# **HOUSATONIC RIVER**

## **General Electric Company's Comments on EPA's Model Validation Report**

MVR Peer Review Meeting

June 28, 2006

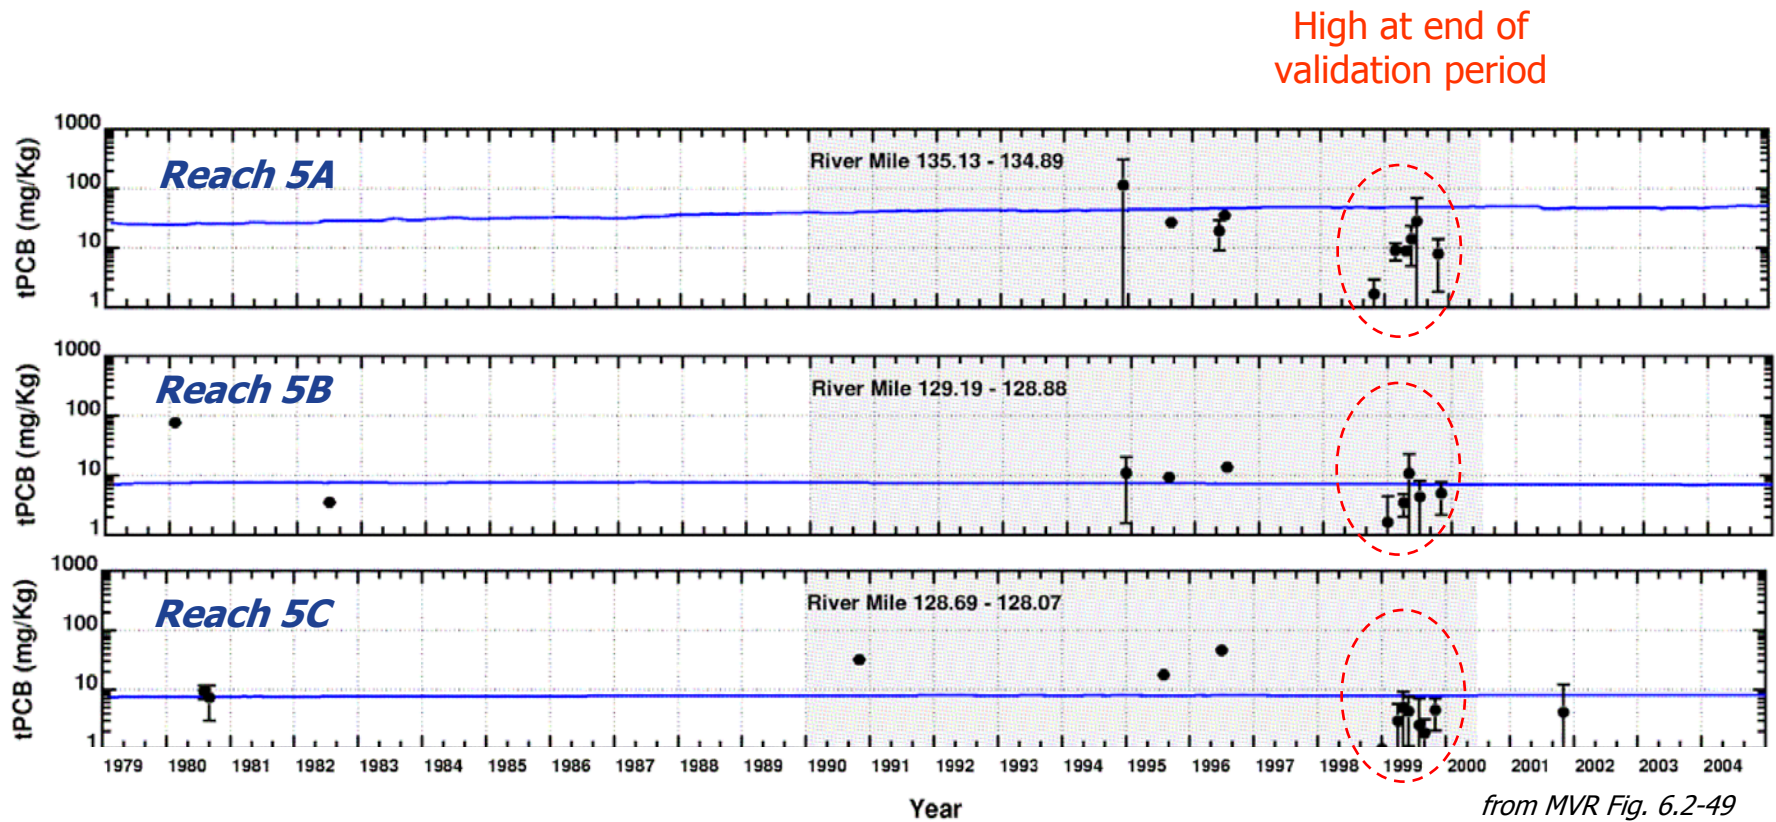
- Model under-predicts data at the beginning and over-predicts data near end of the validation period in many “spatial bins”, resulting in incorrect prediction of temporal trend

- Other examples showing model results that do not match the data:

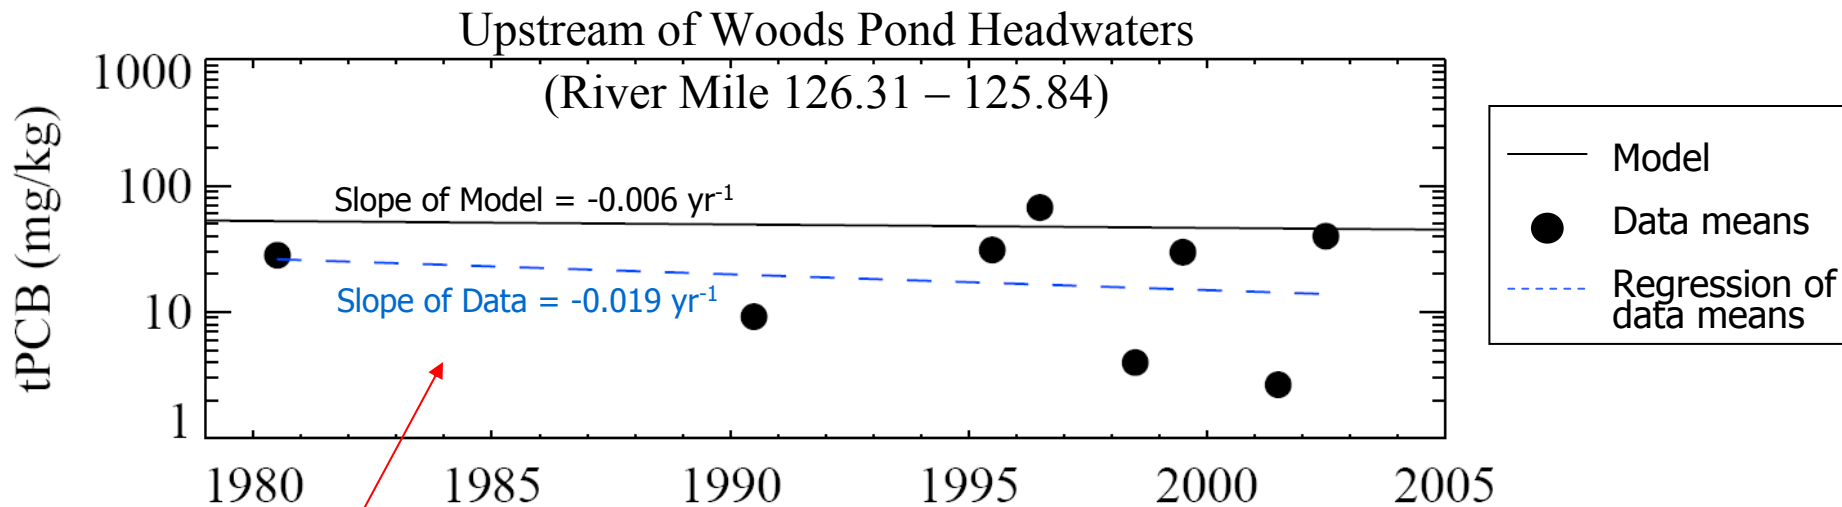
- To evaluate if the model captures the trend in the data, QEA conducted an analysis to compare slopes by spatial bin:
  - For a given spatial bin, annual means of data were regressed (log-linear) and the computed slope was compared with the slope of model predictions (from the MVR Doc. Overview Mtg. figures), e.g.:

Slope of data is 3X greater than slope of model

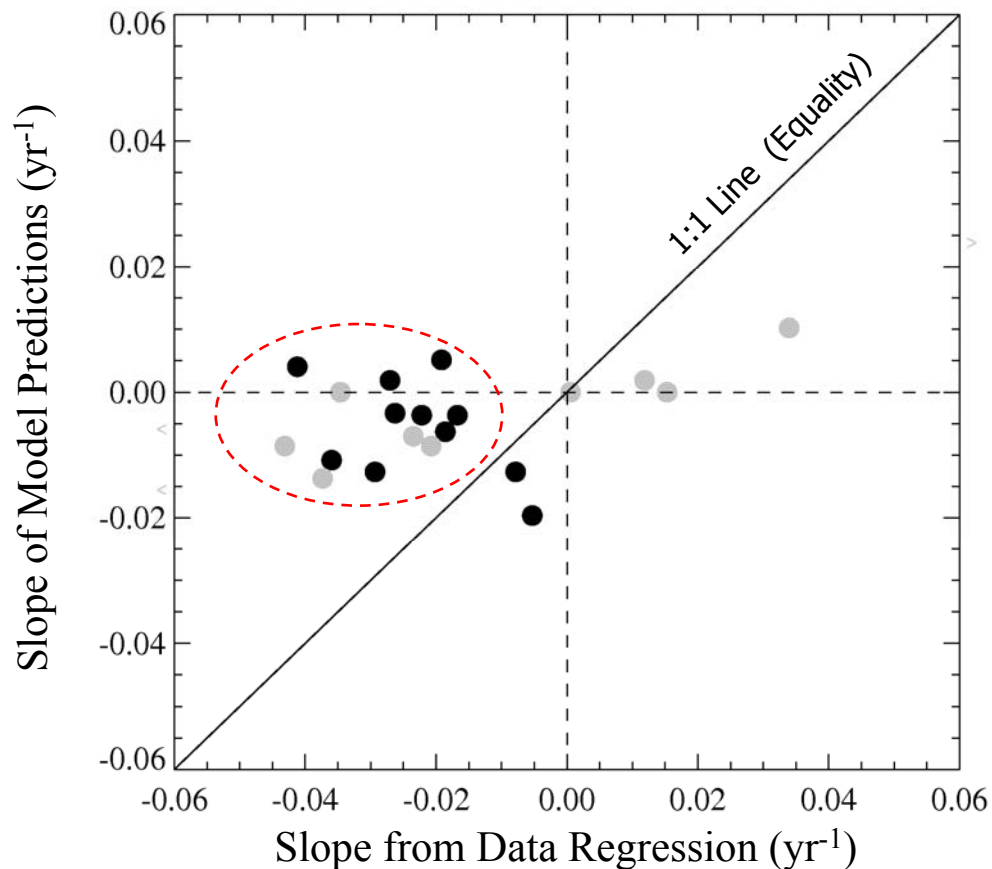
For a majority of the spatial bins:

- Slopes of the model generally near zero (i.e., no change over validation period)
- Slopes of the data means more variable, but generally negative (i.e., decrease over validation period)

**Model-predicted trends of surface sediment PCBs are inconsistent with the data during the validation period, which draws into question the model's ability to predict the system's long-term response to potential remedial actions.**

from MVR Fig. 6.2-45

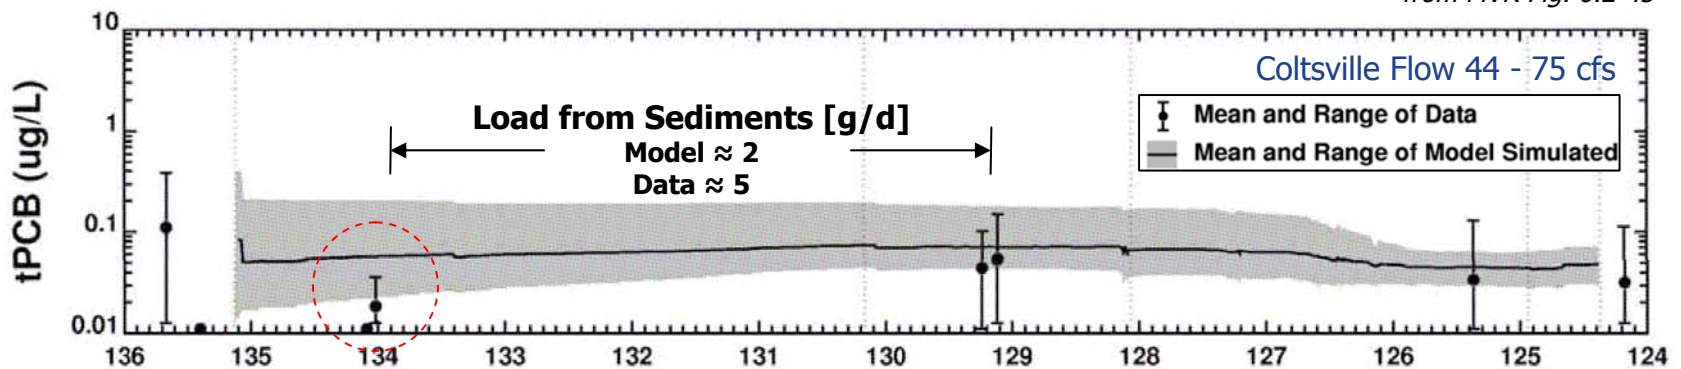
- EPA model does not capture longitudinal gradients in low flow water column PCBs

- PCB flux from sediments between Holmes and New Lenox Rd. is under-predicted by a factor of 2-3

derived from MVR Fig. 6.2-39

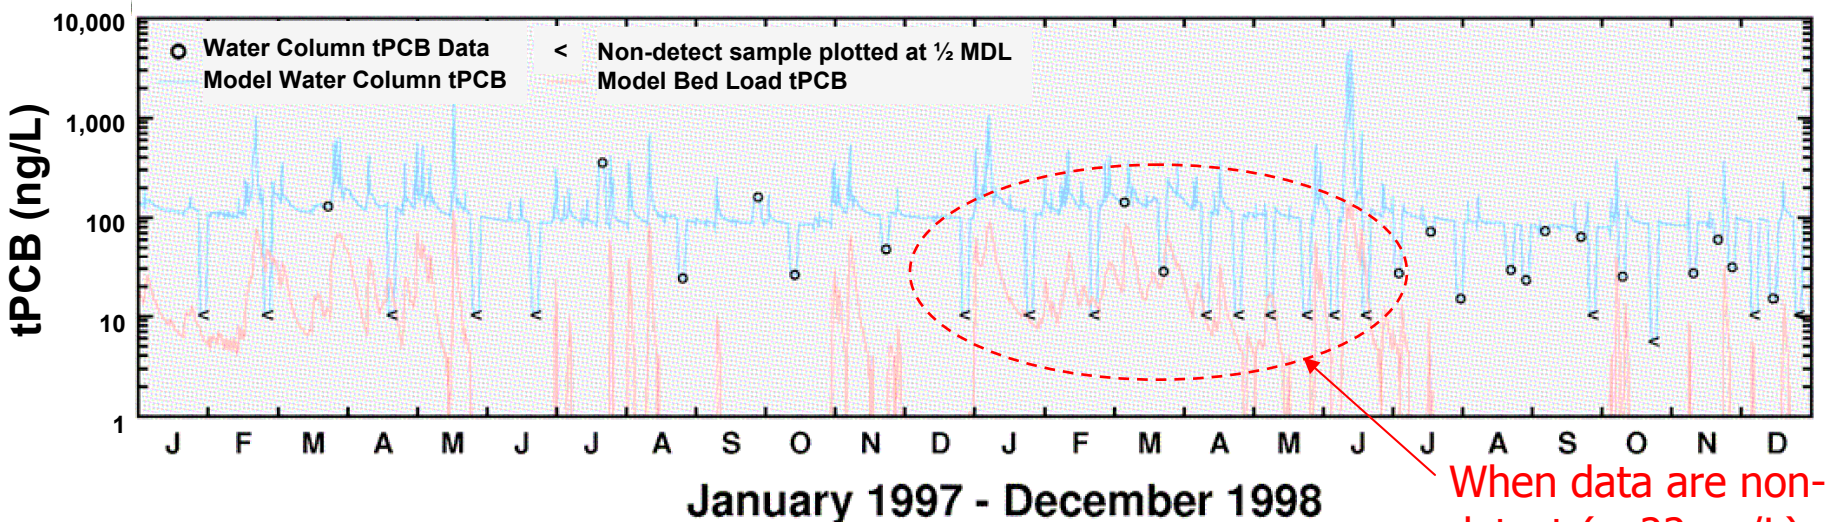
- **One possible reason:**
  - East Branch PCB and TSS boundary conditions tend to overestimate non-storm data, by a factor of 2 to 5

When data are non-detect (< 22 ng/L), model predicts ~100 ng/L

**Low flow water column PCB concentrations are consistently over-predicted in both the East Branch boundary condition and at Holmes Road. In order to match concentrations at downstream locations, the model must under-predict the PCB flux to the water column from the**

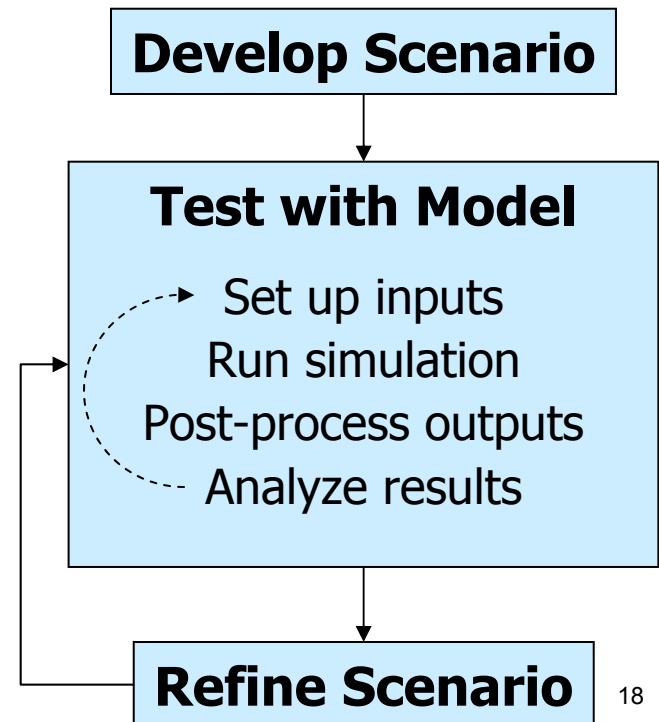
- EPA model's bed layering and depth at which subduction velocities are applied result in an overestimate of vertical mixing in sediments
  - Model assumes that sediment processing by benthic invertebrates occurs at the depth of sediment layer interfaces in the model
  - In fact, many organisms included in EPA's calculation of subduction velocity inhabit shallower sediments, and thus do not move sediments across the model sediment layer interfaces
  - EPA's subduction velocity is too low to keep 7 cm completely mixed as the model assumes
- Overestimation of vertical mixing results in an overestimate of the reservoir of "surface" sediments, which keeps the water and sediment from responding to changes in PCB inputs

*In quiescent areas of the system, where biological activity is likely the predominant mechanism for mixing sediments, vertical mixing is overestimated, which likely leads to incorrect prediction of temporal trends in fish PCB concentrations*

from MVR Fig. 6.2-3, 1985

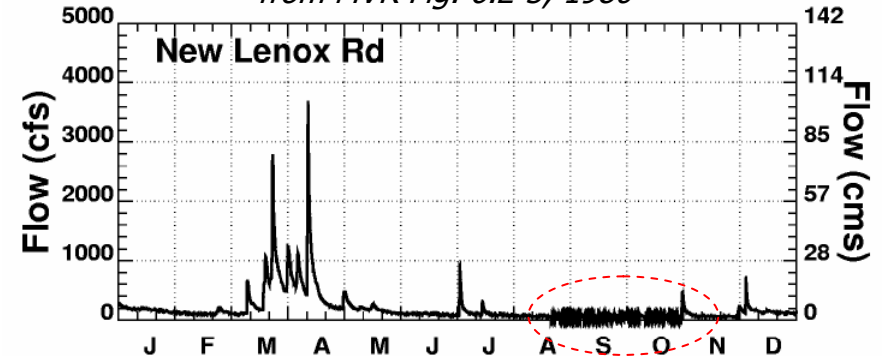
- Oscillations and negative flow rates predicted by the hydrodynamic model at low flows

Negative flow rates

**The potential numerical instabilities with EFDC need to be further evaluated, as they may be indicative of larger problems with the**

*Fig. derived from Doc. Overview Meeting Presentation*

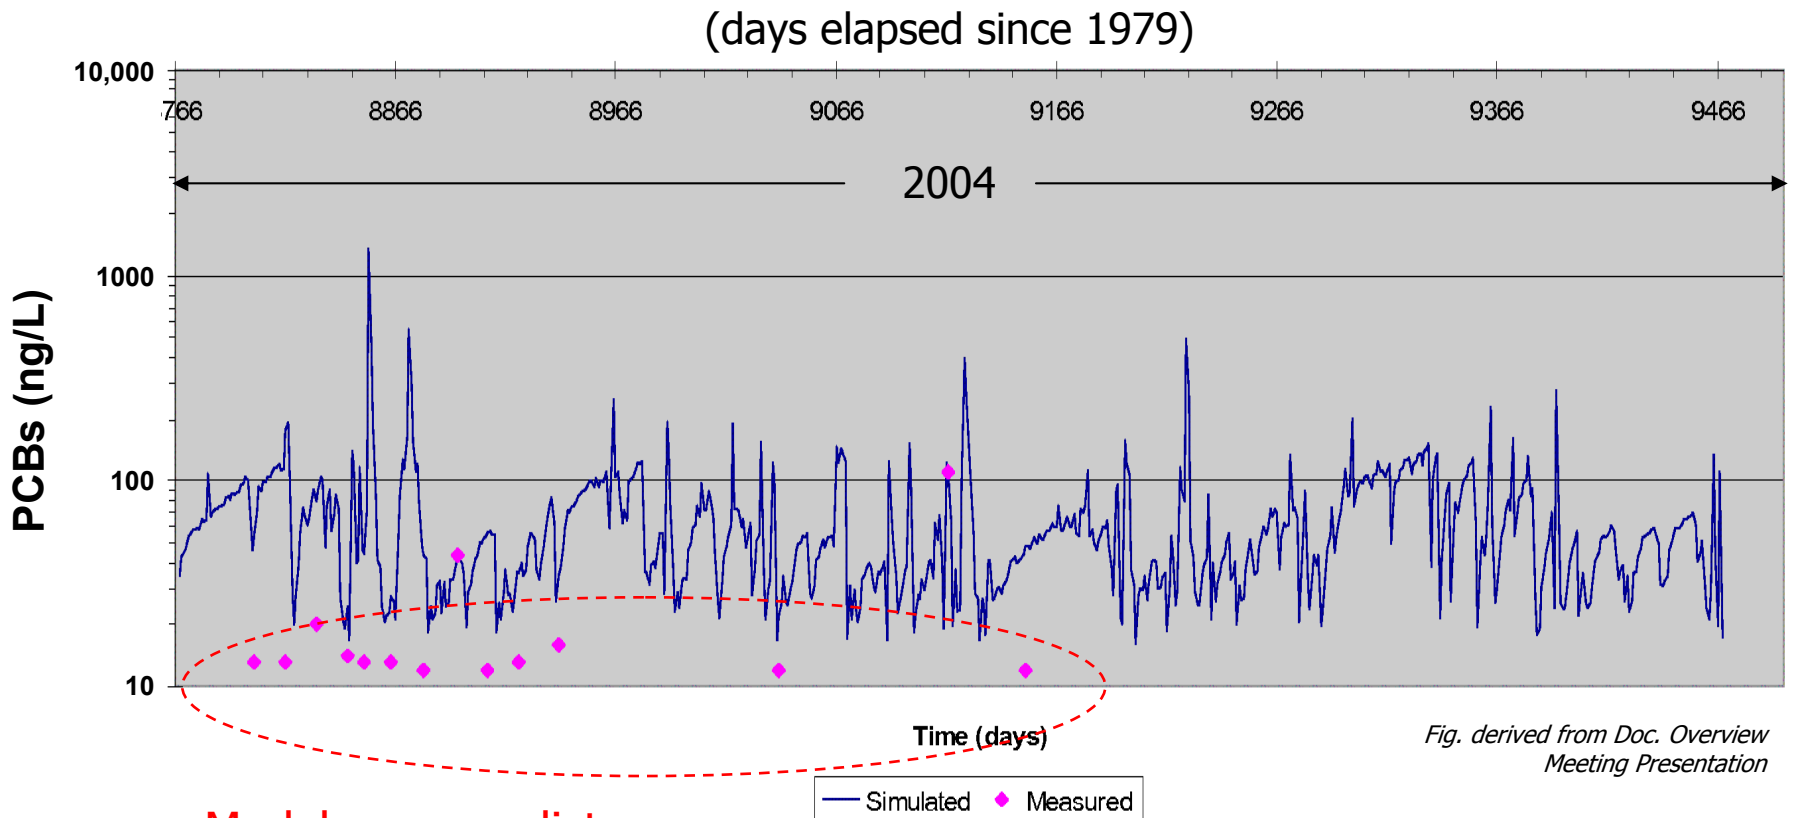
- **Upstream Model results do not match the data:**

**Model over-predicts  
water column PCB data**

*Fig. derived from EPA response to Panel's Doc. Over. Questions*

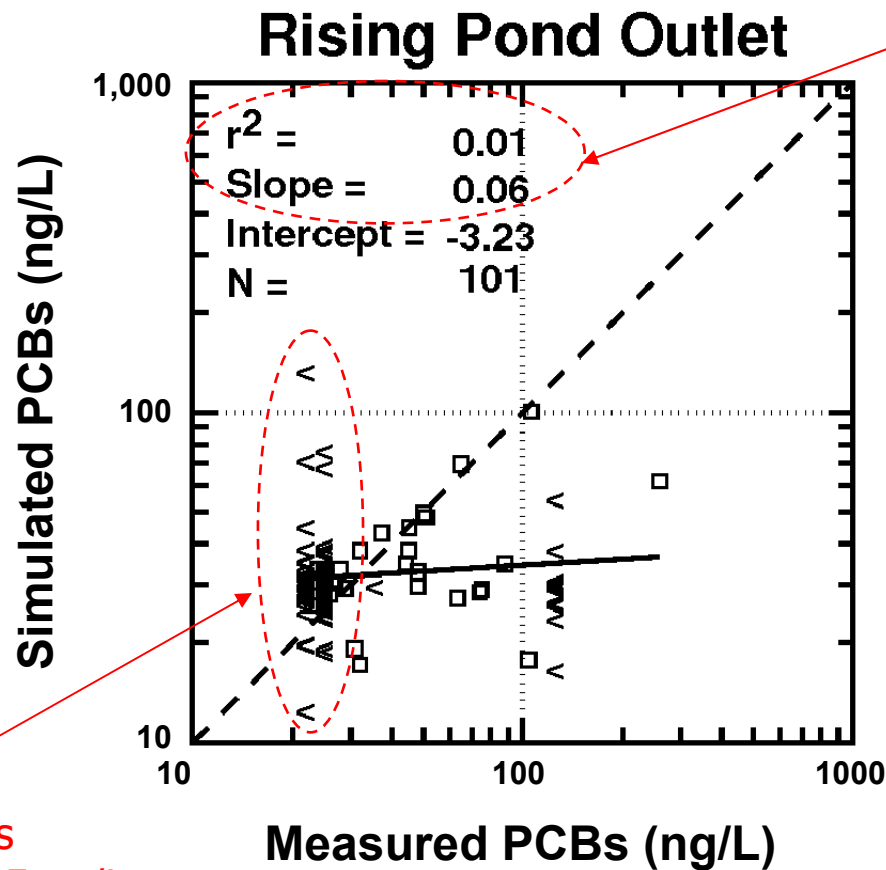
- Downstream Model results do not match the data:

Model provides poor fit to water column PCB data

Large # of samples below MDL of 22-25 ng/L for which model predicts ~30 ng/L or higher

from MVR Fig. 6.2-55

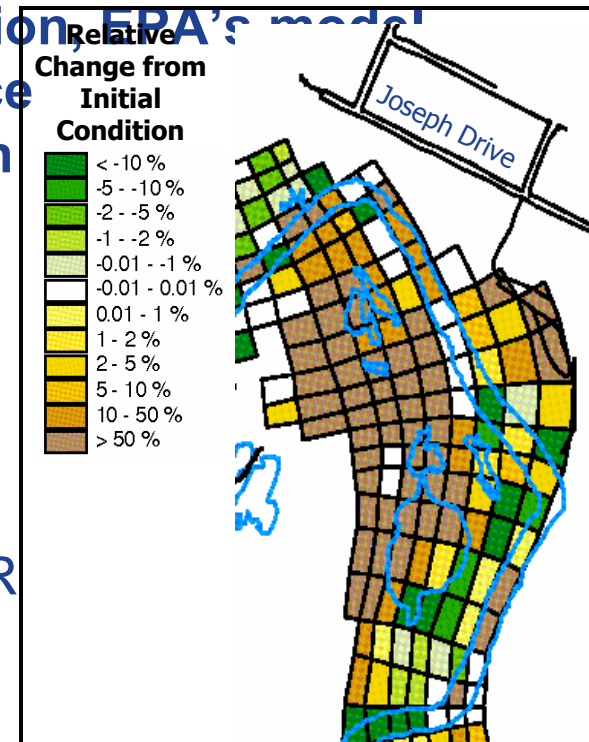
- The initial conditions (1979) for model validation were specified using floodplain data collected in 1998-99
  - This approach implicitly assumed the model would calculate little to no change in floodplain PCBs over the 26-year validation period
- However, at the end of the 26-year validation, EPA's model predicts relatively large changes in surface soil PCBs for some areas of the floodplain
  - Contradicts underlying assumption that little change occurs
  - Model results at the end of the 26-year validation are inconsistent w/ recent data
  - However, no model-data comparisons were presented for floodplains in the MVR
- Indicates model in its current form is inadequate for predicting PCB deposition in the floodplains
